**SERVICE INSTRUCTION****Introduction of a new turbocharger assy. with new ECU software and exhaust requirements for ROTAX® Engine Type 915 i A (Series)**

ATA System: 78-20-00 Turbocharger

Introduction of a new turbocharger assy. with new ECU software and exhaust requirements for ROTAX® Engine Type 915 i A (Series).

Fig. 1

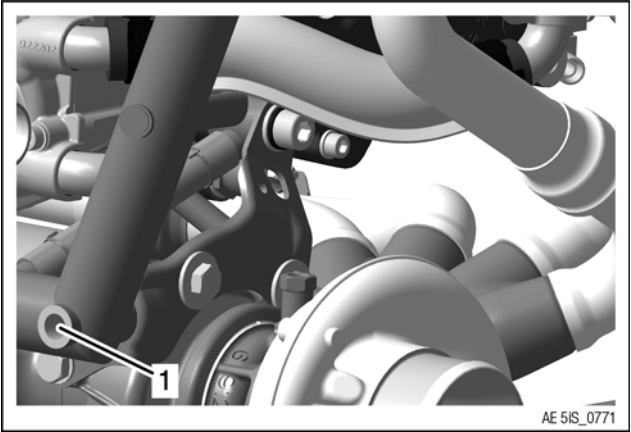
Connection turbocharger bracket with engine suspension frame requires a Metric or UNF fixed connection.

1 Connection turbocharger bracket with engine suspension frame

Fig. 16

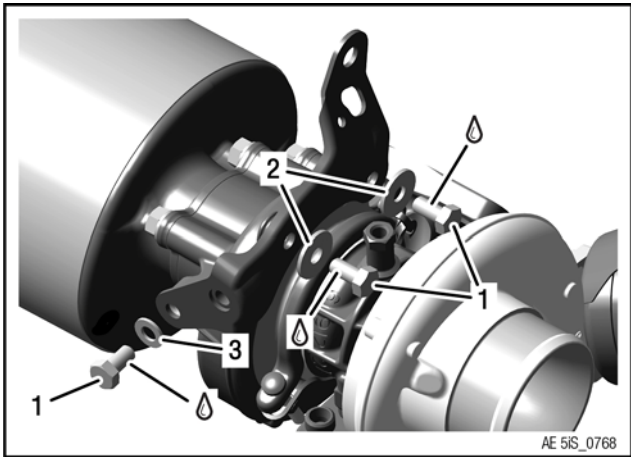
Turbocharger bracket integrates a captive nut used for engine ring mount and aircraft suspension frame attachment. It is available in Metric (M10) part no. 851298 or UNF (3/8-24) (AN6) part no. 851282.

Step	Procedure
1	Apply LOCTITE ANTI SEIZE to the hex. screws M8x16. Tighten the bracket to the turbocharger using 3 hex. screws M8x16 with 1x washer 8.4 and 2x washers B 8.4 (bigger outer diameter). Tightening torque 25 Nm (18 ft. lb.).

Fig. 17

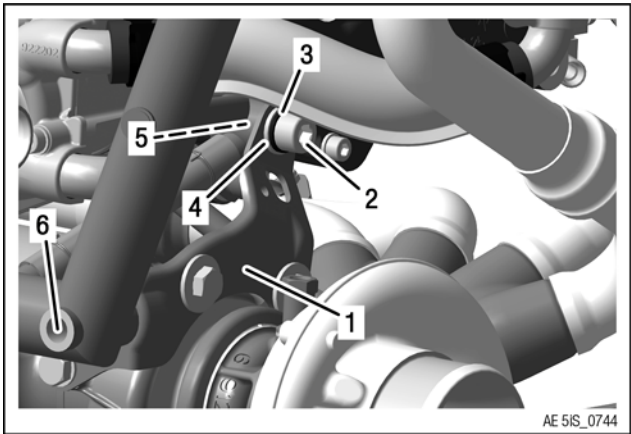
Step	Procedure
1	Place distance spacer 10.5/17/15 into the engine suspension frame.
2	Screw turbocharger assembly to the engine housing, complete with muffler and turbocharger bracket with washer, lock washer and Allen screw M10x50. Tightening torque 60 Nm (44 ft. lb).
